TOWN OF GLASTONBURY
GL-2020-19
WELLES-TURNER MEMORIAL LIBRARY RENOVATIONS AND ADDITION PROJECT
ADDENDUM NO. 4
10/9/2020

1. Replace the following drawings in their entirety:
A3.01
2. Revise the following drawings per Addendum 01, see attachment 1.
SKA-008, SKA-009, SKA-010, SKA-011

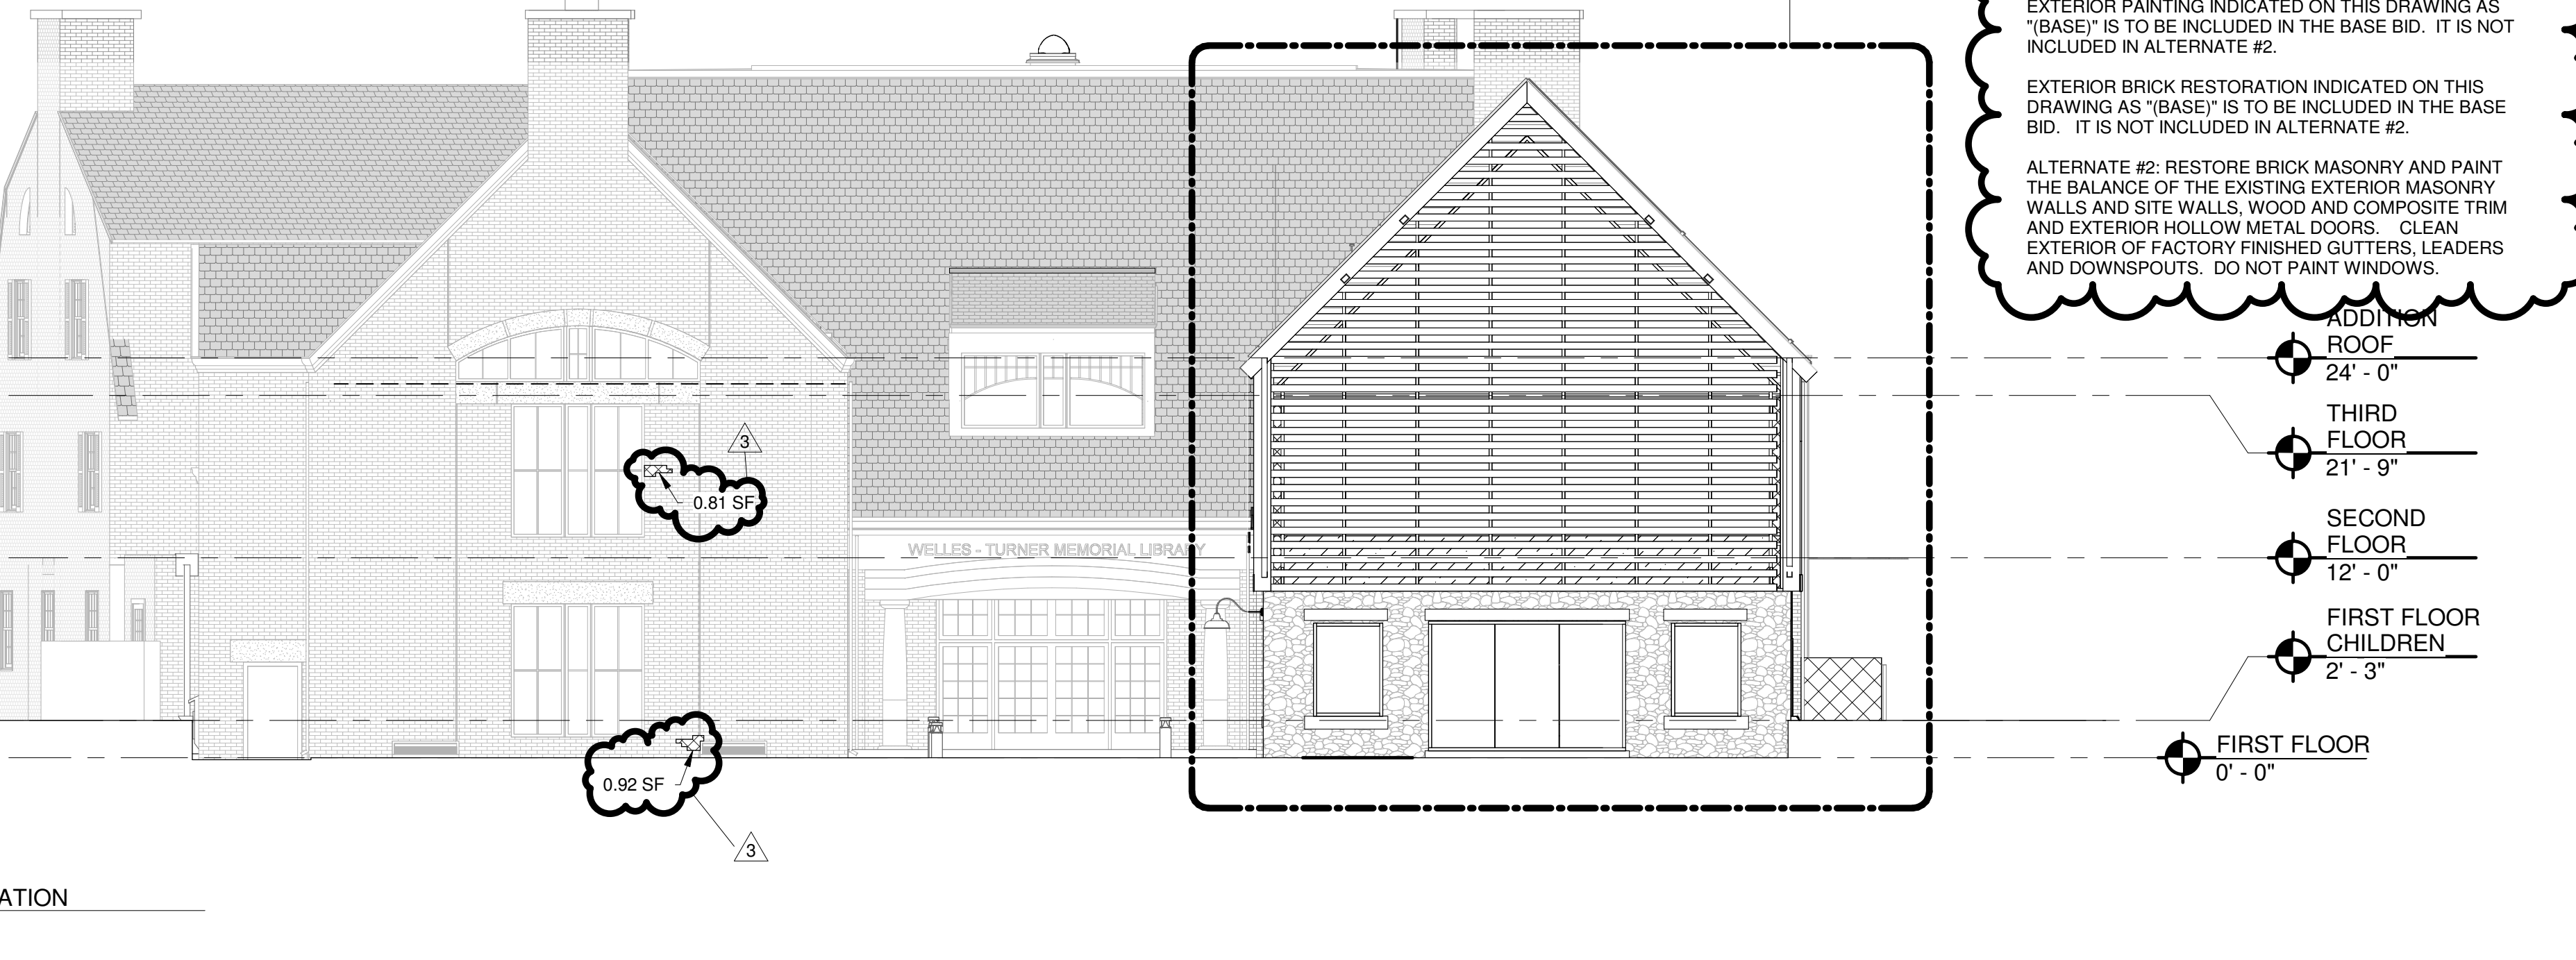
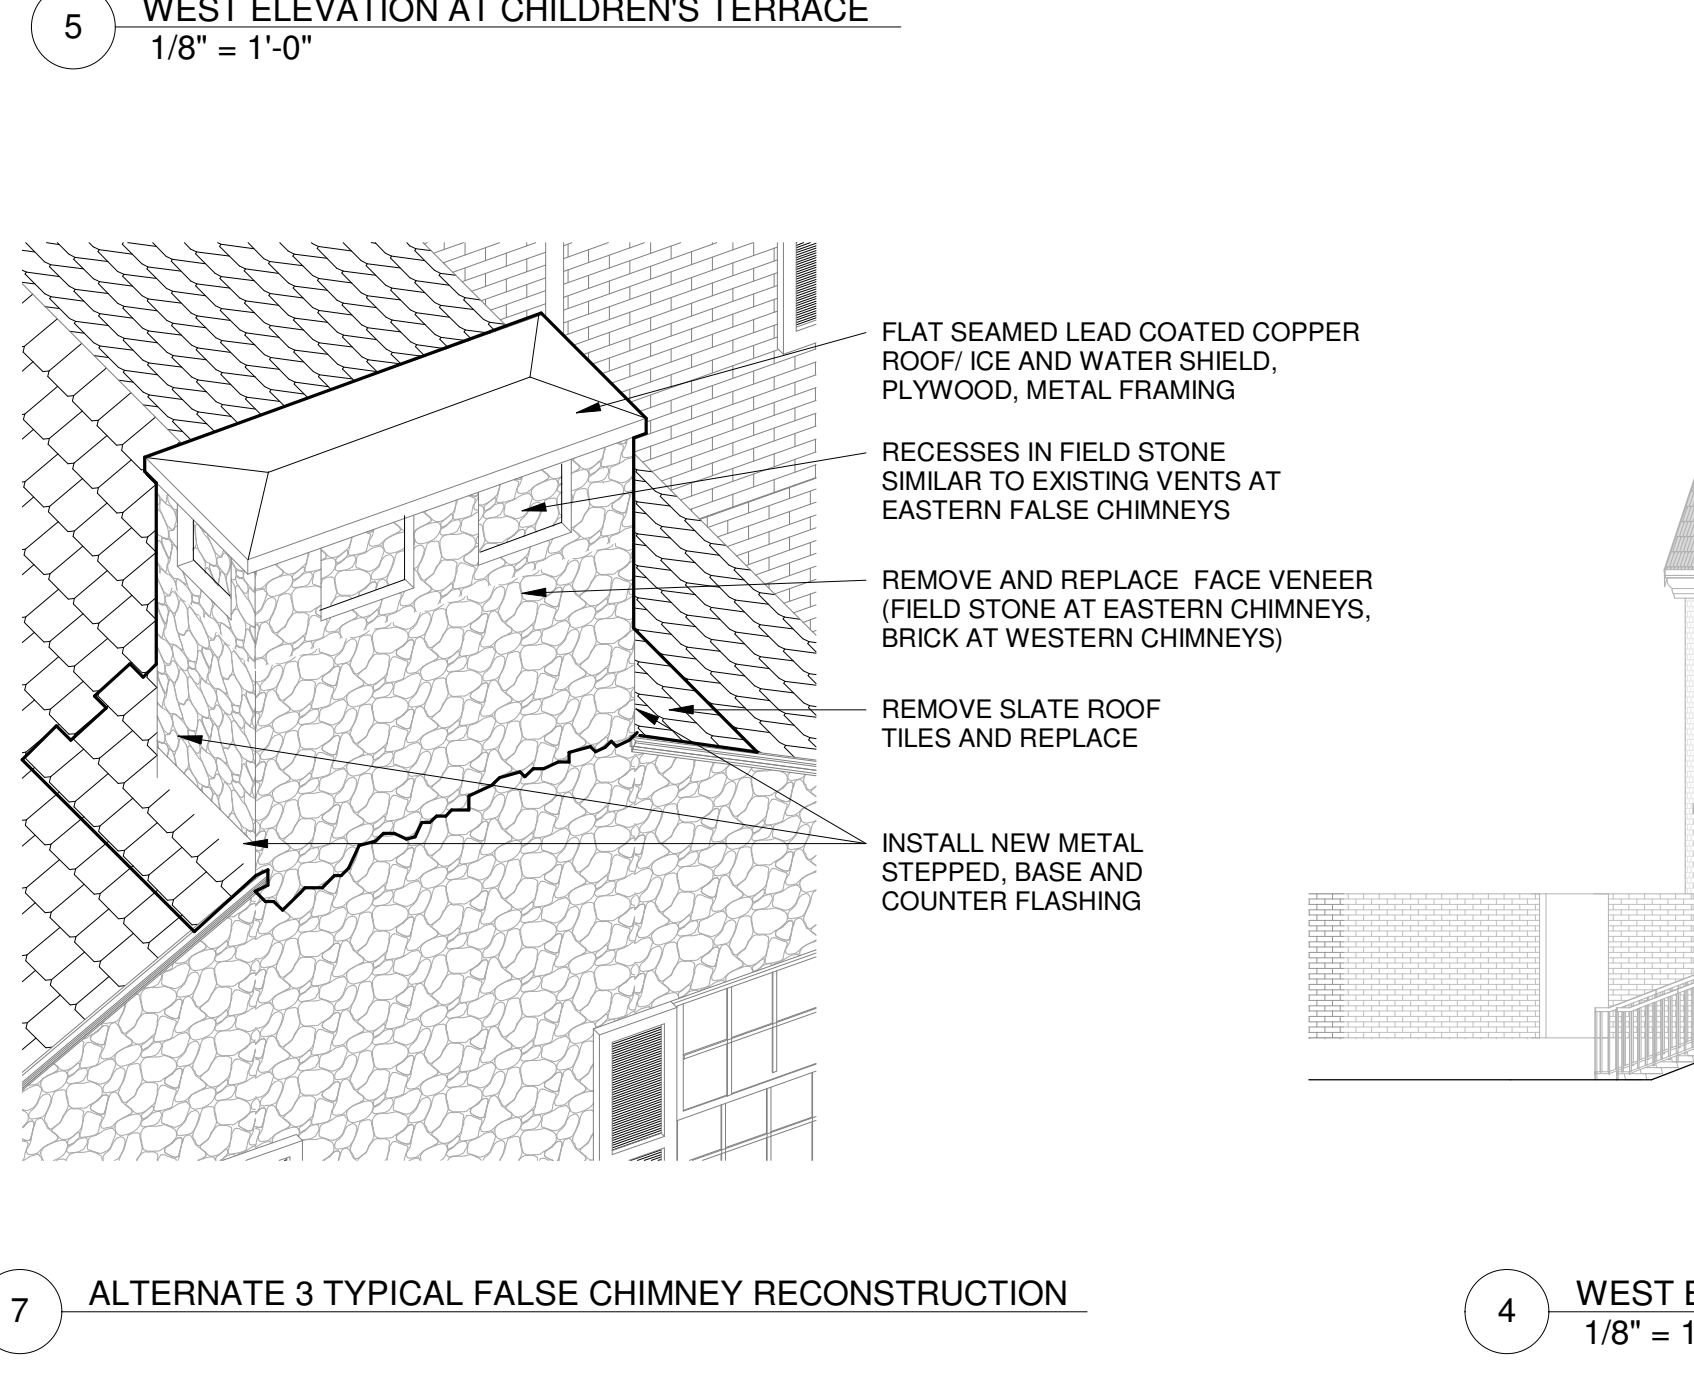
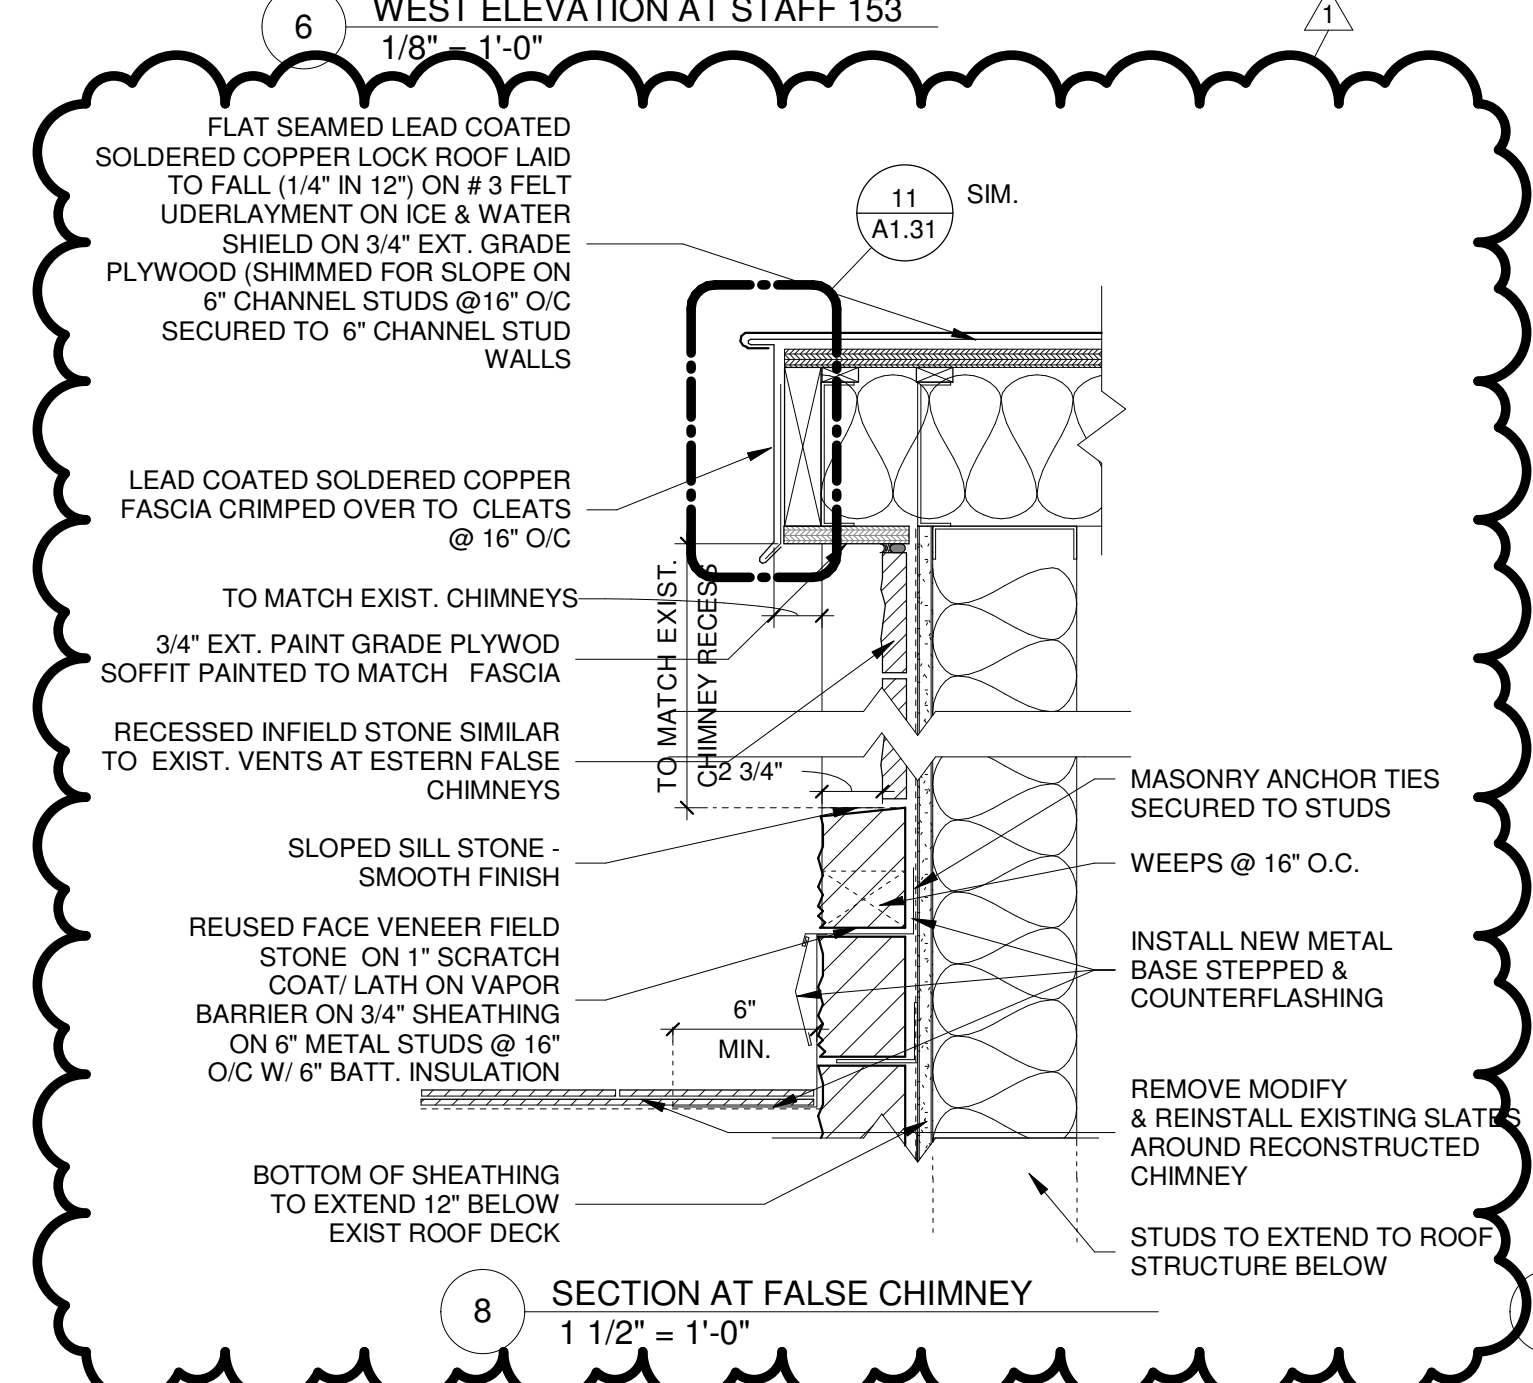
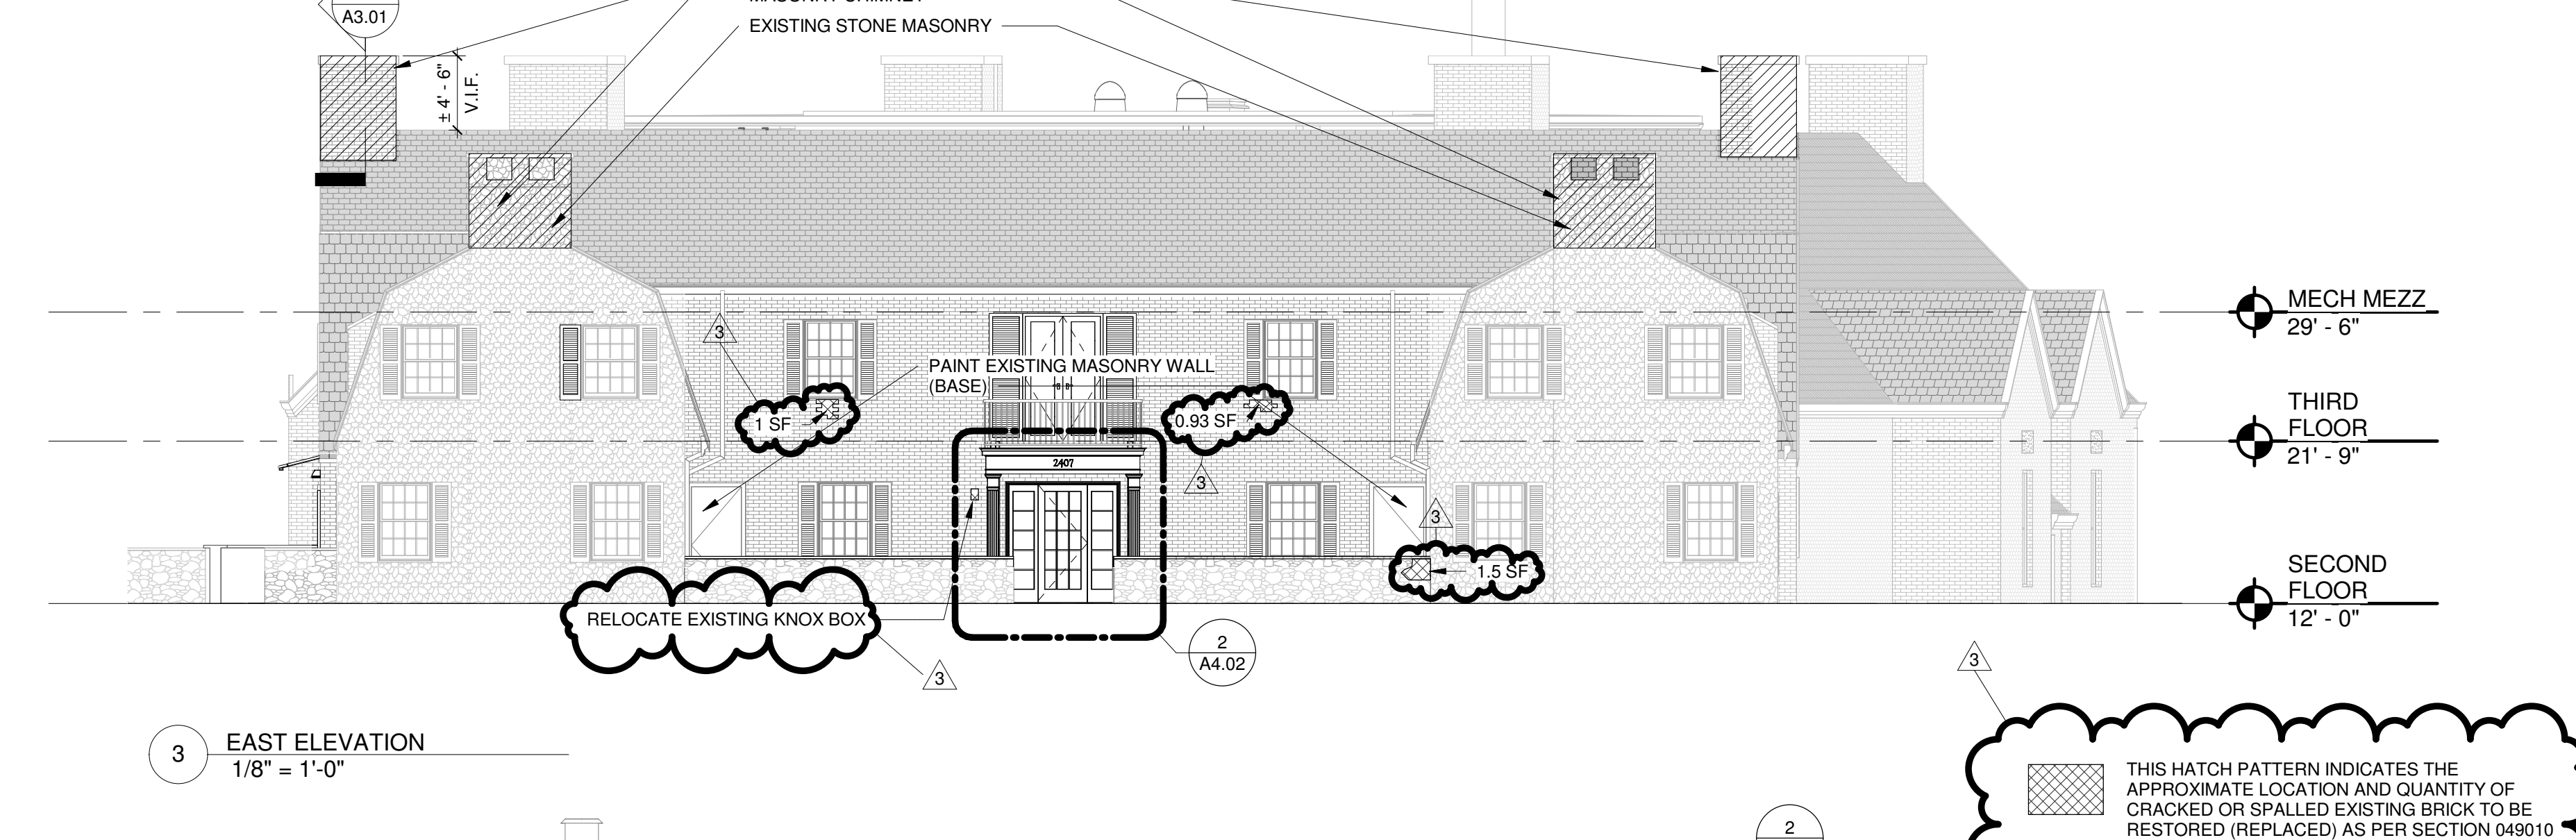
1. Specification Section – Bid Form
 - a. – Revise bid form to add unit price #20:
“Replace 34 square feet of existing brick masonry indicated as “(BASE)” on A3.01 and as per specification section 049010 “Brick Restoration”.

- C. Allowance No. 3: Quantity Allowance: Include 34 square feet of brick replacement at locations shown on A3.01 and indicated as "(BASE)".**
 1. **Coordinate quantity allowance adjustment with unit-price requirements in Section 012200 "Unit Prices."**
